MINING REVIEW

Dartbrook Coal Mine MOD7 IPC Presentation

9 April 2019

Review conducted by
Michael White
BE Mining (Hons), MBA, GAICD
Resources Consultant

Costs Incurred To Operate The Coal Washery

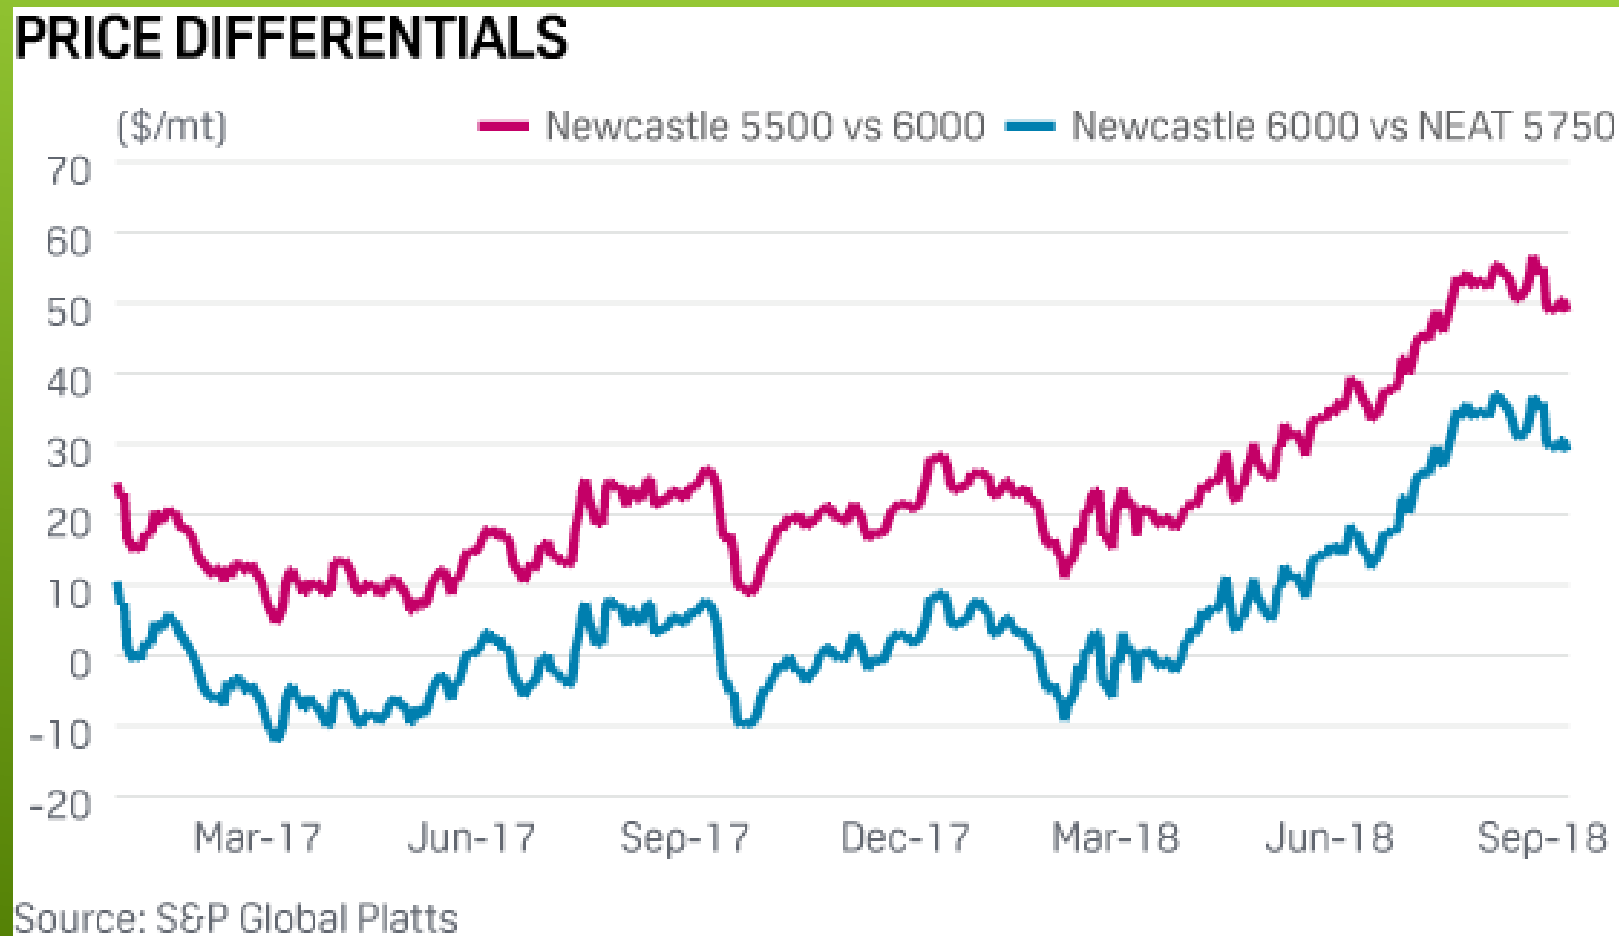
Why Coal Washery Operational Impacts have to be included as part of the Project Impact Assessments?

- To achieve the target product coal quality of 15%-24% ash stated in the Applicant's Response to Submissions over the life of the project some coal washing or blending with lower ash coals from elsewhere will be required.
- AQC have stated they may wash coal at a later stage

Why the Coal Washery is not included in the Project Plan

Dartbrook's Target Coal Product is 5500NAR (Not achievable over the project life) Recent Price

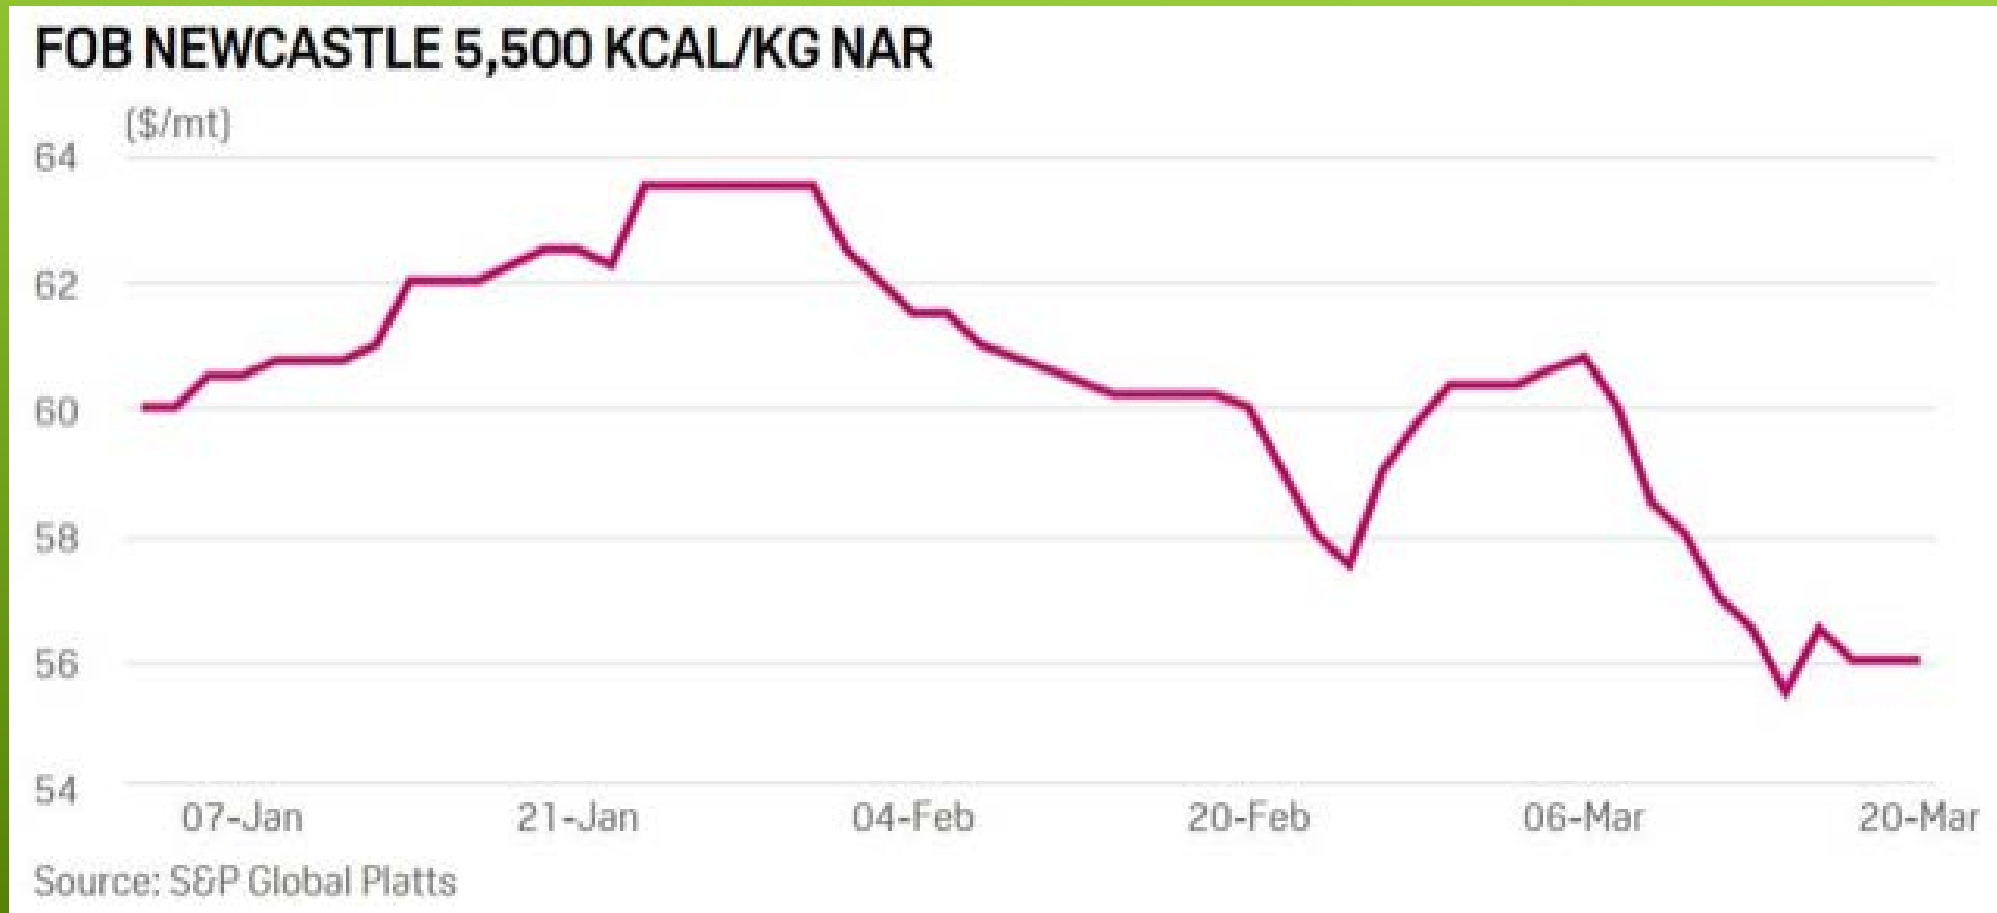
Dartbrook's Target Coal Product is 5500NAR
A growing gap from the Newcastle 6000NAR and the
actual achieved price gap will be greater again

Dartbrook's Target Coal Product is 5500NAR

A growing gap from the Newcastle 6000NAR
